#2014-48
95 Grant St. Apartments – Preliminary/Final PUD
Project Review for Planning and Zoning Commission

<u>Meeting Date:</u>	March 4, 2015 and May 6, 2015
<u>Requests:</u>	Preliminary and Final PUD for a multi-family development in the B-4 Downtown Commercial zoning district.
<u>Location:</u>	95 Grant Street
<u>Acreage:</u>	Approximately 8,300 square feet
<u>Existing Zoning:</u>	B-4 Downtown Commercial
<u>Surrounding Properties:</u>	North: B-4 Downtown Commercial South: B-4 Downtown Commercial East: B-4 Downtown Commercial West: B-4 Downtown Commercial
<u>Staff Contact:</u>	Elizabeth Maxwell (815.356.3615)

PROPOSED SITE PLAN
 SCALE 1" = 15'-0"

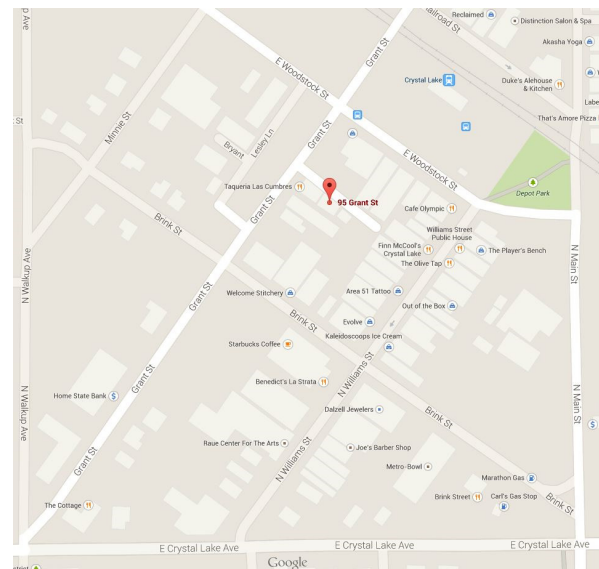
- Multi-Family housing requires 2.25 spaces per unit. This building would require 13 spaces. The Downtown receives a 30% reduction. Only 9 spaces are required. The petitioner plans to provide 8 spaces.
- The parking area does not meet the required width for parking spaces and drive aisles.
- If the building was used for office it would require 36 parking spaces; with the Downtown reduction it would come to 25 parking spaces.

1. Article 4-200 D 4 from the minimum number of spaces required at 9 spaces to allow 8 spaces, a variation of 1 space.
2. Article 4-200 H from the dimensional standards for parking spaces and aisles to allow 8-foot wide spaces and a 22.5-foot drive aisle. The required space is 9 feet wide. The required drive aisle is 24 feet wide.
